**Report of the MQXFA06
Coil Acceptance Review**

US HL-LHC Accelerator Upgrade Project

**Report of the MQXFA06 Coils Acceptance Review
November 17, 2020**

S. Izquierdo Bermudez, A. Ghosh, G. Sabbi

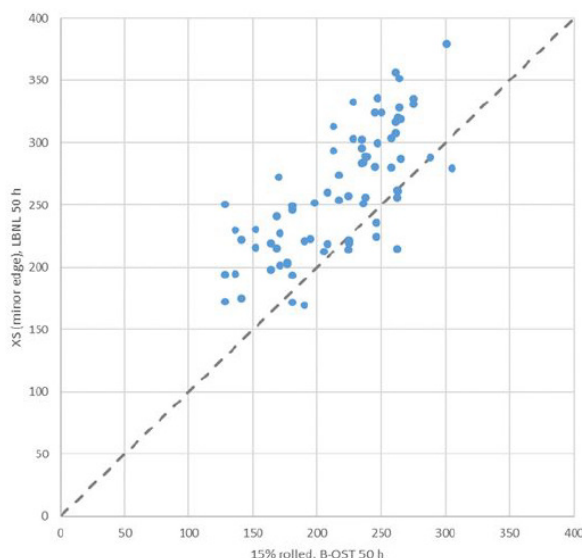
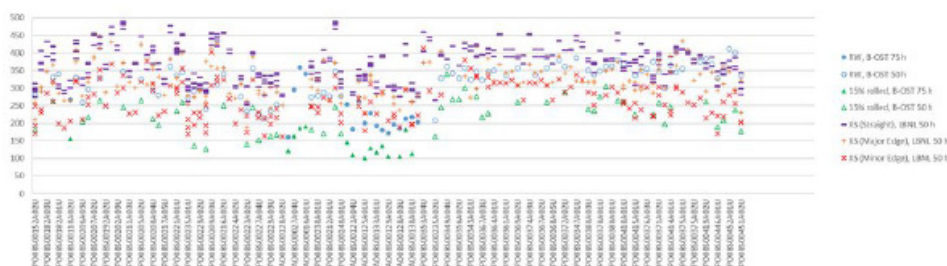
- LBNL RRR measurements still appear to give consistently higher results than those from witness samples, rolled strands, and magnet cold test. Please comment on this. There was some discussion during the presentation, but no convincing argument was made to show that we understand this difference and how to improve.

- The committee appears to imply that the measurement technique is at fault. Let's be clear: the LBNL measurements are accurate and are not biased based on the outcome of numerous inter-comparisons. The differences are actual differences in the samples based on HT and sample preparation or state. We understand the difference fully and it is related to (a) coil reacted over temperature, which affects the witness samples; (b) pedigree of the billet material and the billet manufacturing; (c) agreement between rolled strand data and the data for segments incorporating cable edges

- RRR depends on the HT and sample preparation
 - Coil 211, for example, showed excellent agreement between witness and XS RRR.
 - Coil 119 HT overcooked the coil, so witness RRR is low. LBNL RRR has been consistently with BOST 15% rolled data.

- See below presentation at the 2020 06 03 Conductor Status with CERN

BNL Coils

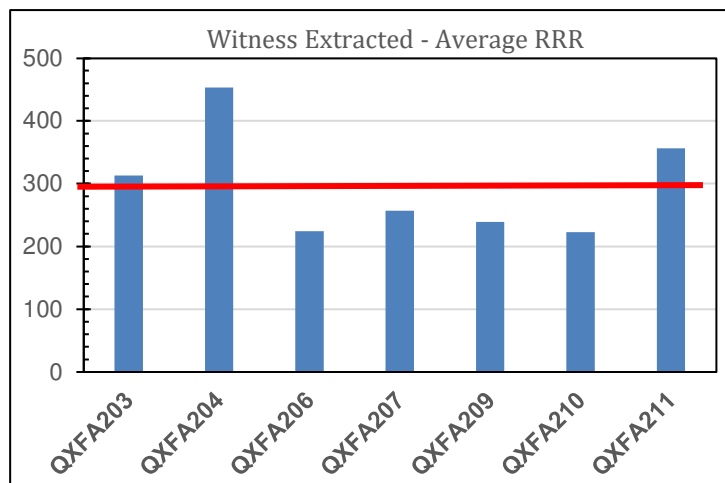
- The coil reaction at FNAL was modified after coil 122 as it was observed that the plateau temperature at 665 C was high (DR 12014). The plateau temperature for Coil 123 was reduced by 4°C. As expected, the RRR of extracted strands for 123 show a higher value as compared to previous coils (see Table).
- We estimate that the coil reaction at 665C at FNAL is at a higher temperature than that at BNL. This observation is based on witness sample measurements at FNAL of the RRR for these and earlier coils that were reviewed previously. This is shown below for BNL and FNAL coils:
